# Access Compliance Report

## Public Rights-of-Way

### (Curb Ramps)

Intersection ID: N/A	Main Street: EUCLID_AV	Cross Street: ATHERTON_ST	Location: W
ADA ID: 7D4BF5996E67	Ramp Type: PerpDiag	Initial Pass/Fail: Fail	Overall Compliance: No
Severity Score: 21.25			
Codes/Mitigation Info/Possible Solution		Field Measurements/Component Compliance

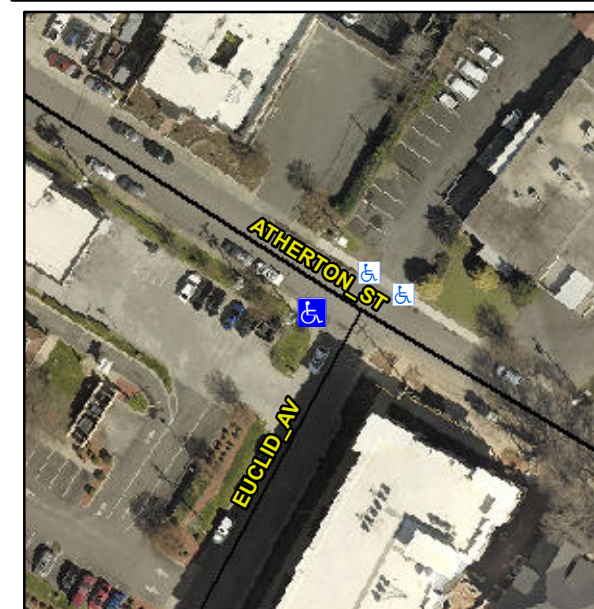
**Not Found, R304.5.1, R304.5.3**

Compliance	Description	Data	Compliance	Description	Data
N/A	Ramp Length (in)	51.0	Yes	Ramp Slope (%)	6.2
No	Ramp Width (in)	37.0	No	Ramp XSlope (%)	5.2
N/A	Flare Type LT	N/A	N/A	Flare Type RT	N/A
N/A	Flare Slope LT (%)	N/A	N/A	Flare Slope RT (%)	N/A
N/A	Flare Traversable LT?	N/A	N/A	Flare Traversable RT?	N/A
N/A	Landing Length (in)	N/A	N/A	DWS Provided?	N/A
N/A	Landing Width (in)	N/A	N/A	DWS Contrast?	N/A
N/A	Landing Slope (%)	N/A	N/A	DWS Length (in)	N/A
N/A	Landing X Slope (%)	N/A	N/A	DWS Full Width?	N/A
N/A	Landing Curb? (Y/N)	N/A	N/A	DWS Offset (in)	N/A
N/A	Shared Landing?	N/A			
N/A	Gutter Ponding?	N/A	N/A	Gutter Slope (%)	N/A
N/A	Gutter Lip Ht (in)	N/A	N/A	Gutter X Slope (%)	N/A
N/A	Painted X Walk1?	No	N/A	Painted X Walk2?	No
	X Walk 1 Direction	To SE		X Walk 2 Direction	To NE
N/A	X Walk 1 Width (in)	N/A	N/A	X Walk 2 Width (in)	N/A
	X Walk 1 Slope (%)	1.0		X Walk 2 Slope (%)	6.6
	X Walk 1 X Slope (%)	8.0		X Walk 2 X Slope (%)	2.9

**Remove & Replace Curb Ramp With Two New Directional Ramps or Equivalent.**
